**APPA's comments on
National Emission Standards for Hazardous Air Pollutants from Coal-and Oil-fired Electric Utility
Steam Generating Units and Standards of Performance for Fossil-Fuel-Fired Electric Utility,
Industrial-Commercial-Institutional, and Small Industrial-Commercial-Institutional Steam
Generating Units**

(NESHAP Proposal Also known as EGU MACT or Mercury HAPs Proposed Rule)

Docket Number EPA-HQ-OAR-2009-0234;

August 2, 2011

Figure 2: Visualization of timeline needed by utilities to install pollution controls for compliance as opposed to timeline allowed by U. S. EPA.

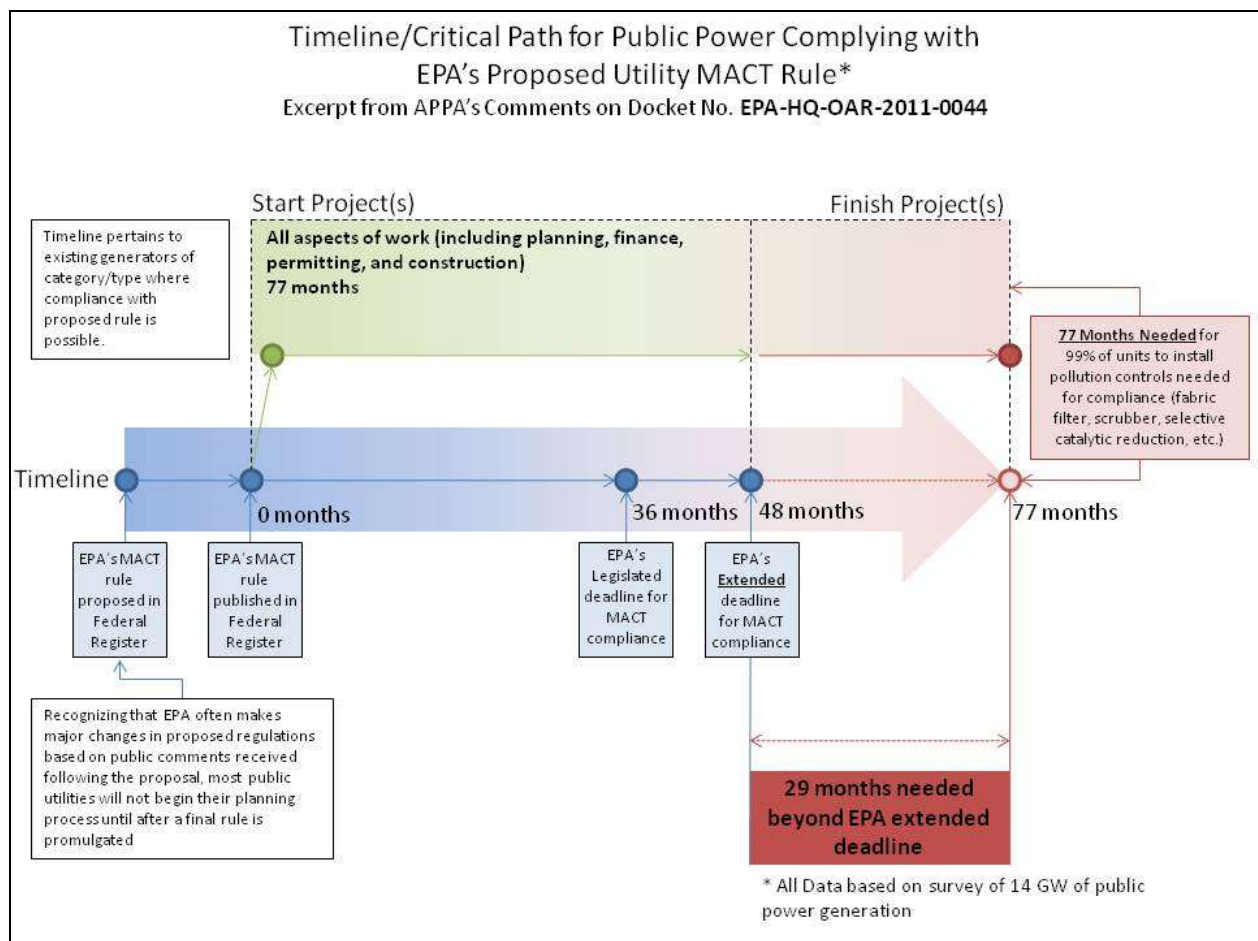
However, four of the past retrofits described by respondents were either unusually faster or slower than the rest of the reported retrofits. Excluding these units as "outliers," which seems reasonable if one takes the "percentile" approach, would yield the same average (49 months), but a range of 54-65 months for the 90% to 99% UPL, or 66-77 months if a year is added for facilities retrofitting two units. Please see Figure 2 below for a visualization of the time needed to complete retrofits for compliance as compared to the time allowed by U. S. EPA.

- Unusual situations are not reflected by the above average, but probably fall within the range represented by a "90 percentile" approach. One respondent speculating on a future retrofit cited the need to replace a hot-side ESP with a FF. This change would mean that the air heater would no longer receive "clean" flue gas, since the fabric filter system could not tolerate the high temperature of gases entering the air heater, leading to reconfiguring the air heater to a "dirty" system, and relocating a major electrical subsystem within the existing unit. The respondent judged that this work could not be completed in 4 years.

Figure 3: Average natural gas prices at the wellhead, citygate, and for commercial consumers from EIA data

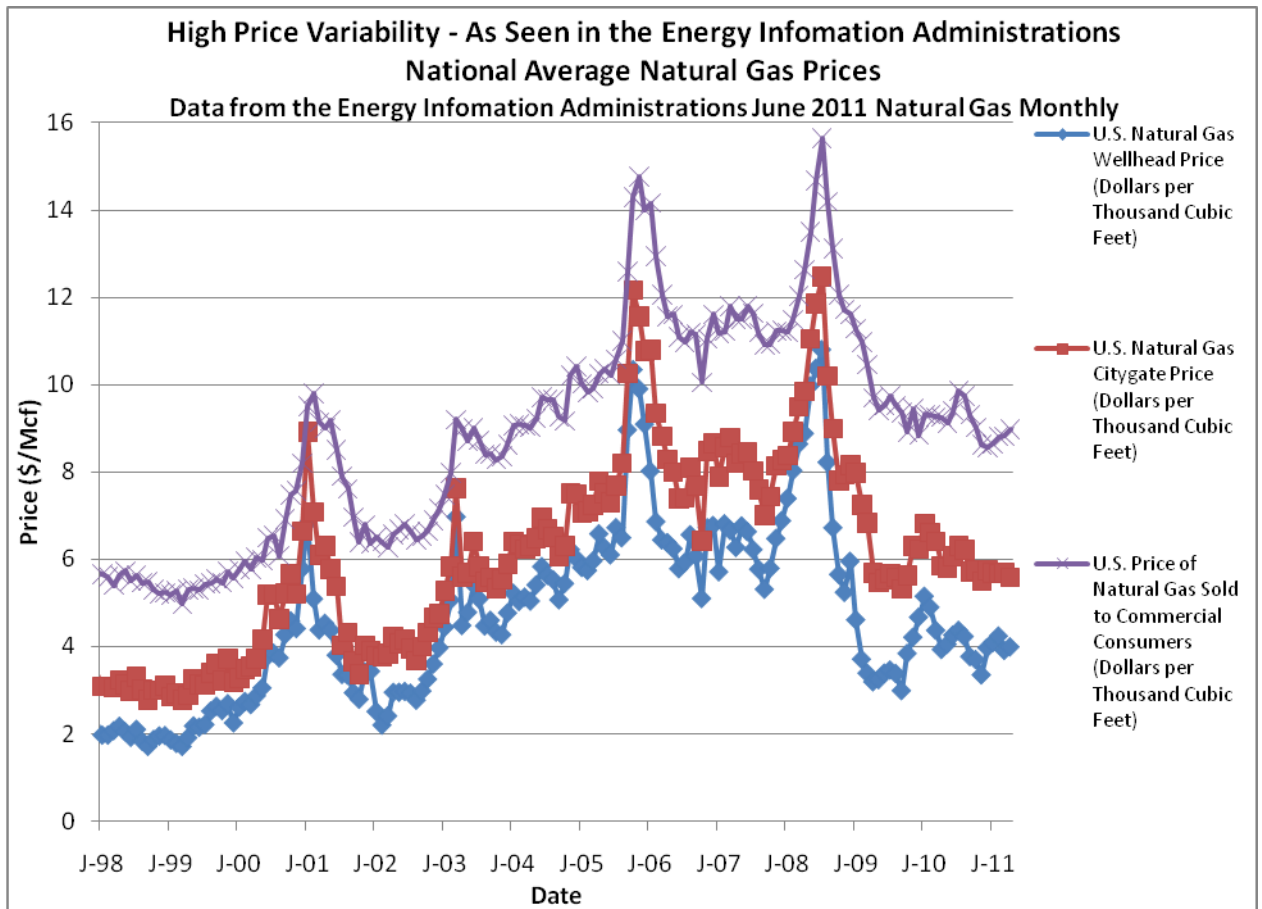
In section 8.10 (Projected Fuel Price Impacts) of U. S. EPA's Regulatory Impact Analysis for the Toxics Rule, the U. S. EPA states that consumer natural gas price impacts from the rule are expected to range from a 0.6% to 1.3% increase. APPA believes this is a significant underestimation and encourages U. S. EPA to reevaluate impacts of the Toxics Rules projected price impacts using a range of natural gas prices (and other key variables). In its alternative case analysis, U. S. EPA should at a minimum use a set of natural gas prices that include a hedge on the bet that natural gas prices will stay low for the foreseeable future.

Long-term natural gas prices are notoriously difficult to predict and monthly spot prices have varied in the last five years from as high as \$13 per MMBtu to below \$3 per MMBtu; as far as we know no government agency or consultant has a consistent track record getting them right. Despite the popular view that shale gas makes natural gas available at low prices as far as the eye can see, policy analysis should take a more neutral view and consider a plausible range that natural gas prices take, recognizing forecasting difficulties and uncertainty. The U. S. EPA should be particularly careful with the natural gas price assumption given its recognition that higher natural gas prices force more coal-fired generation to retire. A graph of average national monthly gas prices can be seen in Figure 3 on the next page. Significant variability in prices can be seen.

Projecting natural gas prices is further complicated because (a) industrial load and demand for gas has not rebounded to 2008 levels of consumption, and (b) liquefied natural gas exports may influence domestic natural gas prices considerably. It has been noted in the energy trade press that exports from built or pending liquefied natural gas terminals may affect as much as 23% of existing U.S. natural gas production.

Figure 4: Source - Data Dispatch, Feb. 22, 2011 (Used with permission from SNL Energy) See Appendix L for more details.

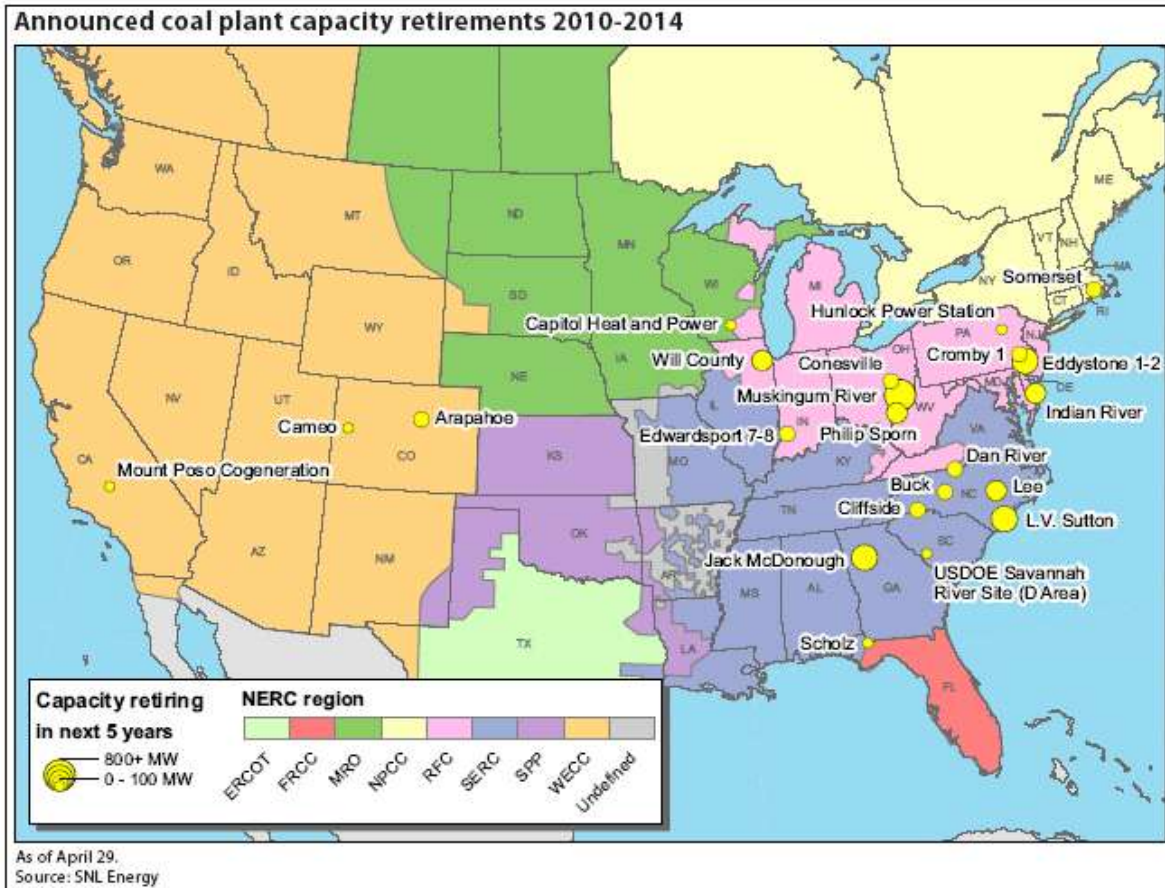
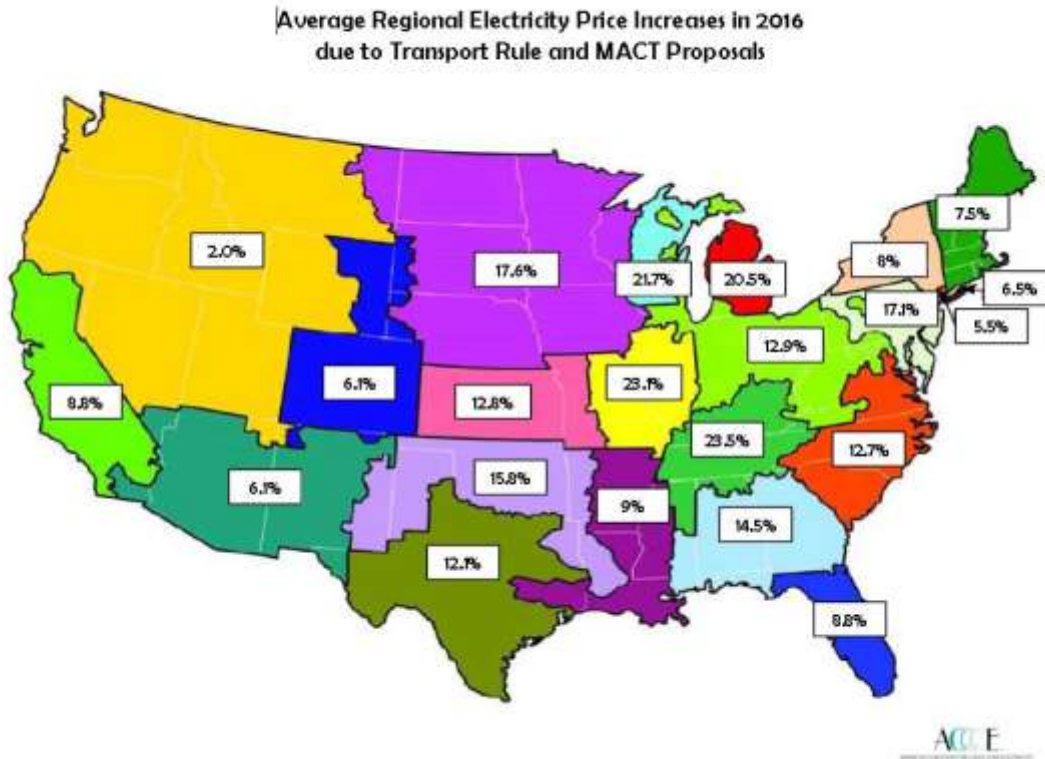
16. The EPA did not adequately consider the distinctly large regional cost impacts of their proposed rule. Figure 4 exemplifies how coal plant closures will have a much more severe impact in different locations. Figure 5 presents a clear picture of how prices will increase due to the combination of the U. S. EPA's Transport Rule and MACT Rule. These projected price increases disproportionately impact coal-dependant regions of the U. S.

Figure 6: Graph of hours of operation it would take to Exceed EPA’s 30 Day Standard as a function of “Normal” emission Rate for Various SSM PM Emission Rates in lb/MMbtu.

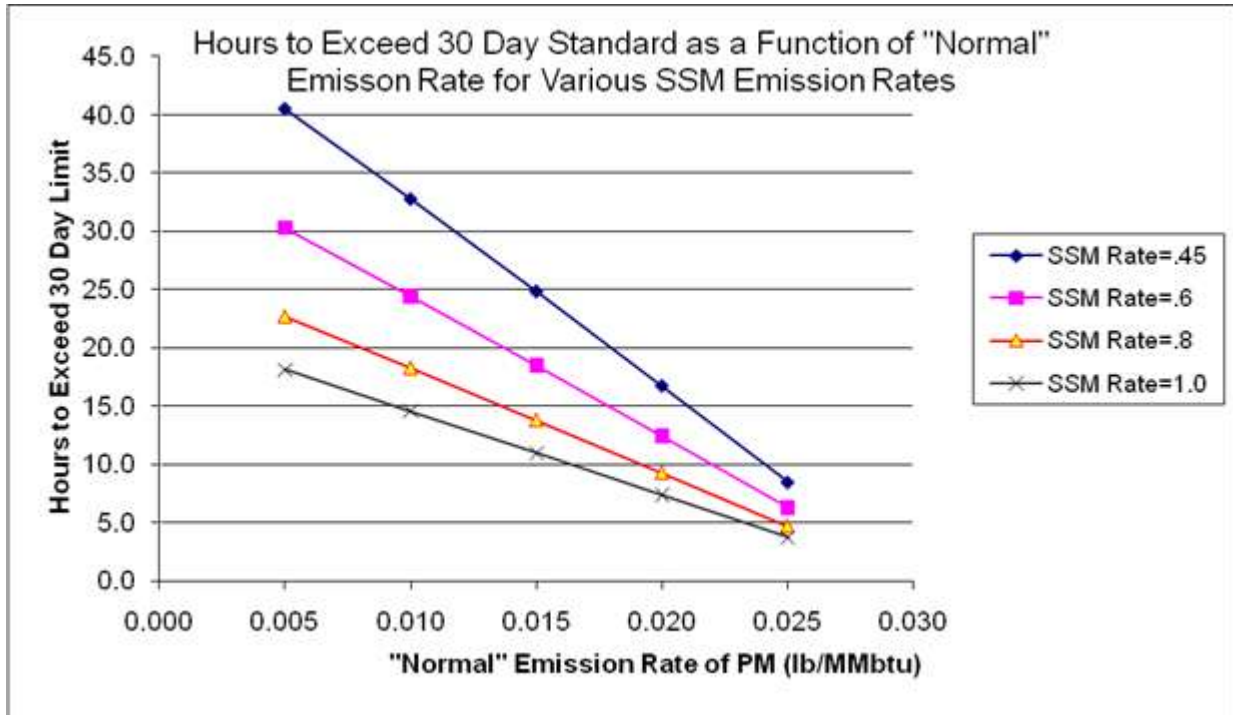
This gives an “X” of 0.023 or 16.7 hours. Thus theoretically, it is possible that several short back-to-back outages could exceed the 30-day standard.

Additionally, if a scrubber is in operation it has the potential to increase PM emissions. If we assume a “normal” PM emission rate of 0.28 lb/MMbtu (“B”) with the scrubber in service combined with an SSM emission rate of 0.45 (“B”), then the hours-to-exceed becomes only 3.4 hours. **In this case, one forced outage might then cause an exceedance. A forced outage is out of the utility’s control and should not ever be able to cause an exceedance of emissions limits. By excluding SSM, EPA has mandated a more stringent standard than 0.03 lb/MMbtu, in some cases this standard is MUCH more stringent depending on the SSM operating emission rate.** A graph of the hours of operation it would take to exceed the U. S. EPA’s 30-day standard as a function of “Normal” emission rate for various SSM PM emission rates in lb/MMbtu can be found below in Figure 6.
